DEV NUMBER: <b>DEV25-0144</b>	ORIGINATOR: <b>CARLOS DOMINGUEZ</b>	DATE: 23-Apr-25	<b>RAIN BIRD</b>		BUSINESS UNIT (SBU and PLANT) W/ PRIMARY DESIGN CON		SHEET:	
			<b>DEVIATION FORM (DRAWING)</b>		025 OTY >>> COM		1 OF 1	
DMR# (IF APPLICABLE):			DEVIATION NEW <input checked="" type="checkbox"/> TYPE: EXTENSION <input type="checkbox"/> OF DEV#:		FORM#233813-01 REV: R			
TOP-LEVEL SKU P/N(S) AND MODEL NUMBER(S): BODY, 1806 (109664)			EFFECTIVITY DATE: 23-Apr-25		EXPIRATION DATE: 23-Jul-25		AFFECTED MFG PLANTS (WHERE USED):	
PROJECT NAME OR NO. (OPTIONAL):					005 LAM <input type="checkbox"/> 013S STL <input type="checkbox"/> 025 OTY <input checked="" type="checkbox"/> 041 NOG <input type="checkbox"/> 008 BUY <input type="checkbox"/> 019 AZU <input type="checkbox"/> 028 TUC <input type="checkbox"/> 047 TUC <input type="checkbox"/> 013E EEX <input type="checkbox"/> 020MX NMD <input type="checkbox"/> 026 ELG <input checked="" type="checkbox"/> CHINA <input type="checkbox"/>

DRAWING NUMBER:			DRAWING REVISION:		DEVIATION REVISION:		DRAWING TITLE/ PART DESCRIPTION:	
109664			BB		BB1		BODY, 1806	
							VENDOR: El Lago	
							PLANT MANAGER Jorge Borquez	
							SBU PRODUCT MGR. OR SBU EN

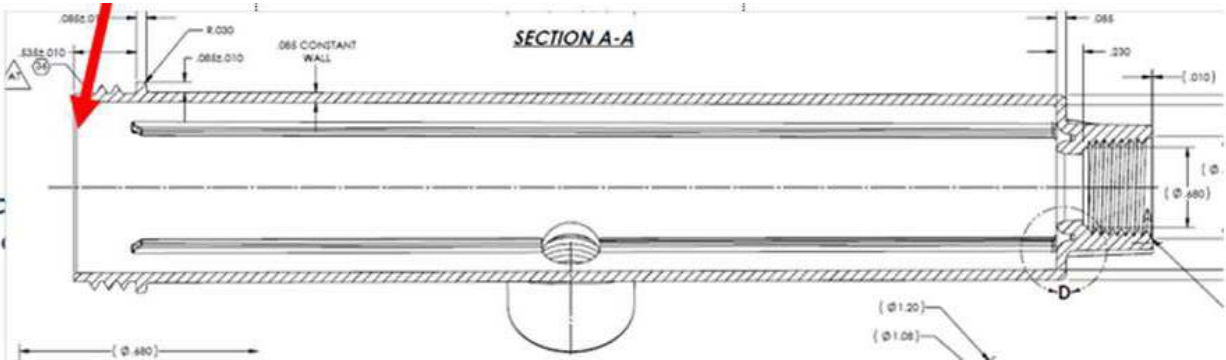
REASON FOR DEVIATION:  Mold #76563 is producing 1806 inlet body 109664 with flash up to .012" (maximum allowed is .010") on diameter 0.1.453". This flash doesn't affect function or assembly. will require Deviation.							APPROVALS (ALL REQUIRED):	
RISK ASSESSMENT/ CORRECTIVE ACTION PLAN (NAMES & DATES)/ COMMITMENT:  Risk is low. Parts were assembled and flow tested with no functional issues. Corrective Action: 1. Run QAP1001 – due 04/25/25. Responsible: Carlos Dominguez 2. Start dimensionning and prepare QAP package – 04/27/25. Responsible: Curiel Omar 3. Run production and complete 12 weeks of inventory before taking the mold for repair– due 07/18/25. – Responsible: Daniel Mendoza. 4. Mold available for repair – 05/24/25. – Responsible: Daniel Mendoza. 5. Repair mold ( Flash) – due 05/24/25. – Responsible: Jonathan Torres.							QUALITY MGR. OR QUALITY ENG. Jose Luis Montero, Ramiro Casas

Cavity 11 up to .011"
